From: Chronert, Roxanne N - DNR
Sent: Monday, April 19, 2021 6:04 PM
To: Trenton Ott
Subject: FW: Vinyl Plastics 02-60-001045
Attachments: Proposed 2021 Landscape (1).pdf

B.1.a. Detailed Site Diagram
 3123 South 9th Street
 Sheboygan, Wisconsin

Figure
 B.1.a.2.

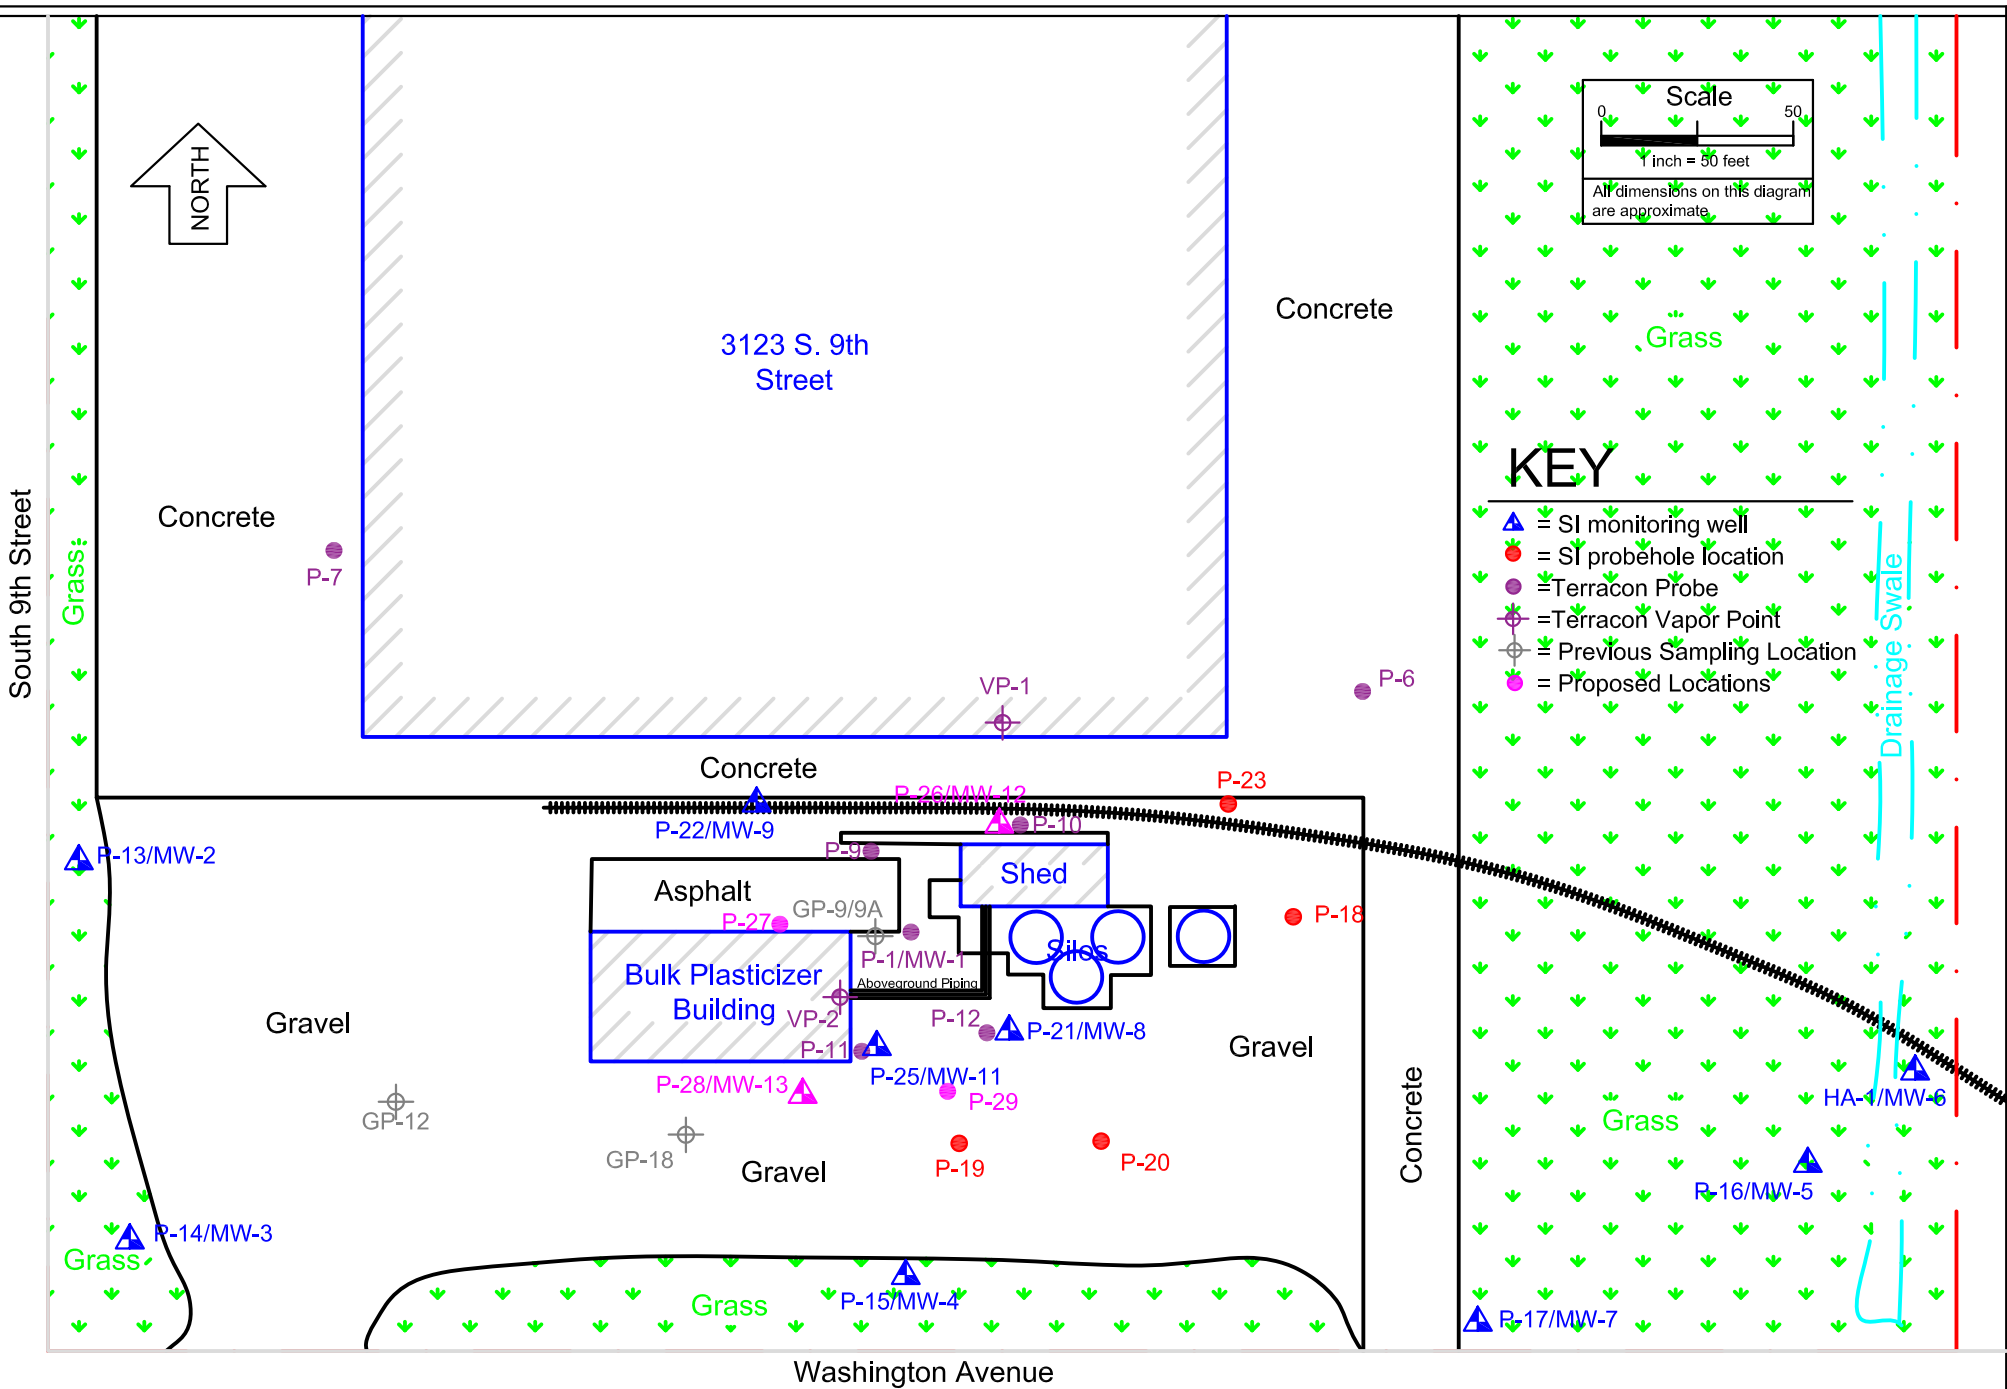
1 – Item #4 - Round of groundwater samples collected from MW-4 to MW-9, MW-11, and the two new wells.

- a. The wells referenced above should be analyzed for SVOCs
- b. Please also collect and analyze a GW sample from MW-5 for SVOCs, as this is the most downgradient well with fluctuating concentrations.
- c. If the Bis (2 Ethyl-hexyl) phthalate concentrations at MW-5 are not stable or receding and/or the downgradient extent is not defined an additional well downgradient of MW-5 may be necessary.
- d. The existing and proposed monitoring wells will need to be resampled in order to establish contaminant trends.

2 - The degree and extent of the of the soil and groundwater contamination will be to be defined to the west (see X on map). We previously discussed the pros and cons of collecting this sample now verses after you have collected the additional samples outlined in your April 14, 2021, e-mail below.
